CITY OF ALBUQUERQUE

**Re: Lot 9 Block 4 Volcano Cliffs SAD 228
6524 Azor Ln NW
Request Permanent C.O. – Accepted
Engineer's Stamp dated: 10-18-17 (D10D003T09)
Certification dated: 3/14/18**

ENGINEER'S SEAL		6524 AZOR LANE NW CURTIS RESIDENCE	DRAWN BY WCVL
		GRADING AND DRAINAGE PLAN	DATE 10-15-17
10/18/17 10/17/17		<i>Rio Grande</i> <i>Engineering</i> 1606 CENTRAL AVENUE SE SUITE 201 ALBUQUERQUE, NM 87106 (505) 872-0999	2181-LAYOUT-10-16-17
DAVID SOULE P.E. # 14522			JOB # 21811

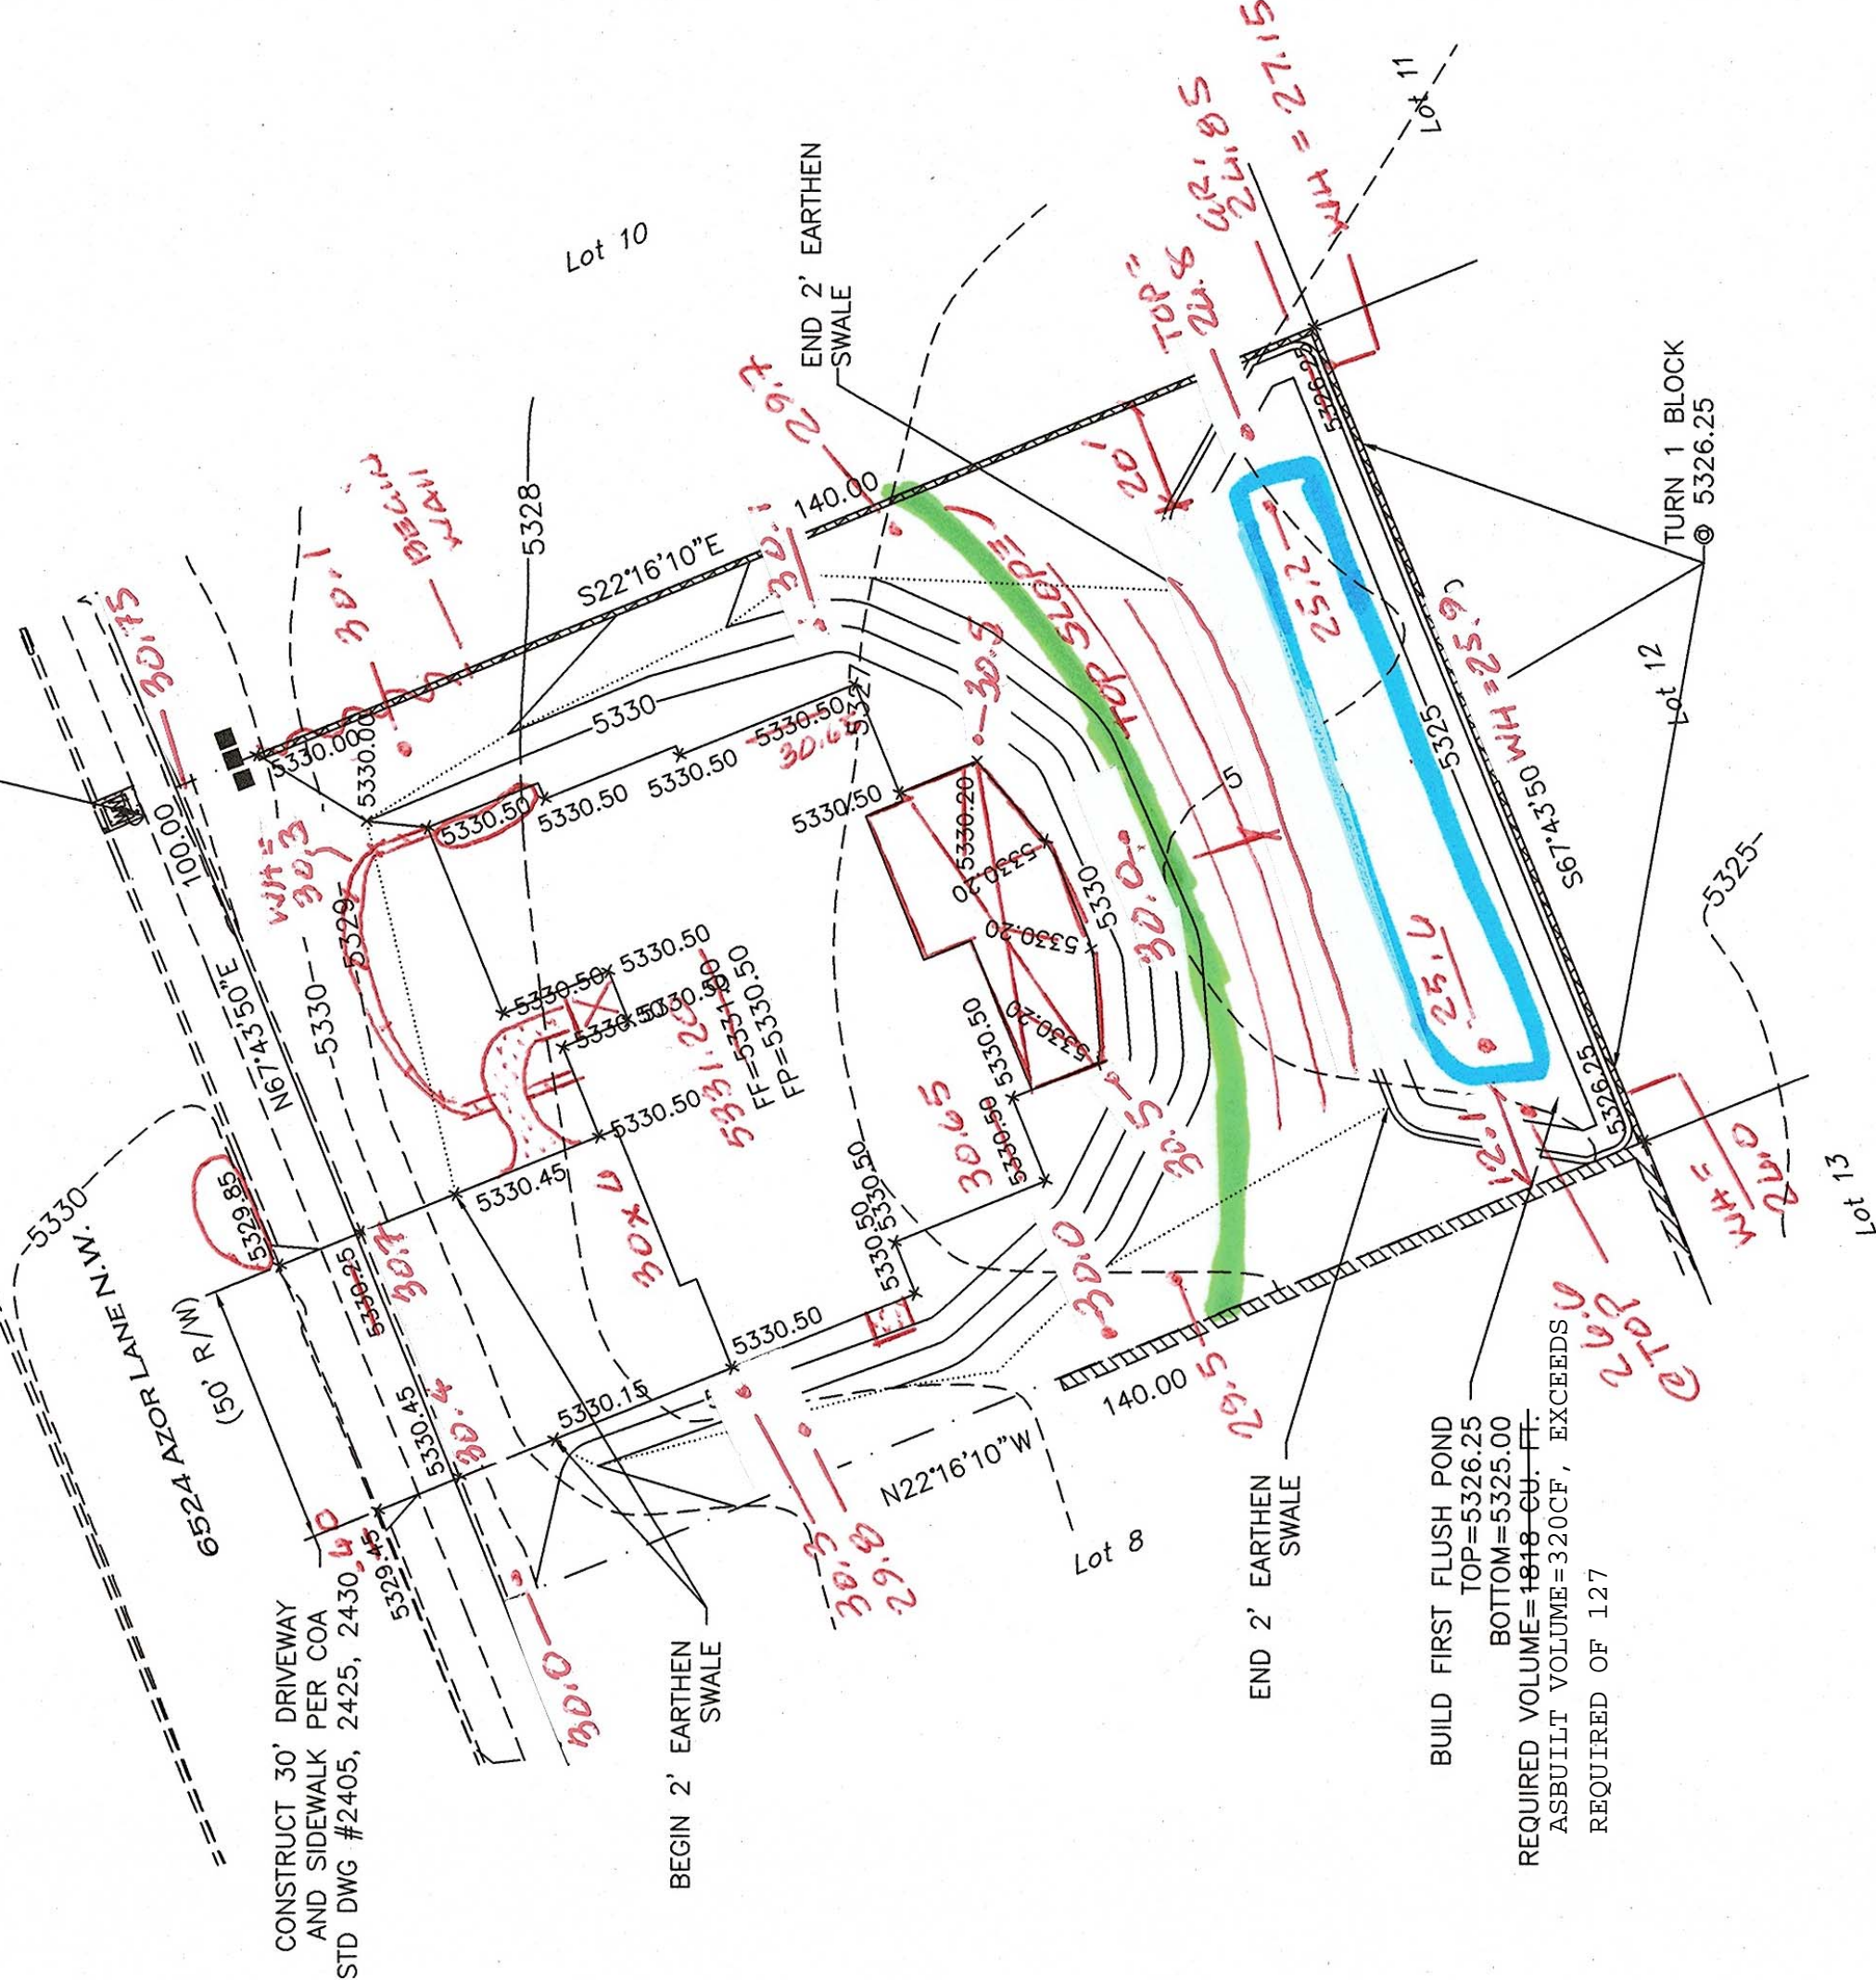
Based on the Certification received on 3/14/2018, the site is acceptable for release of Certificate of Occupancy by Hydrology.
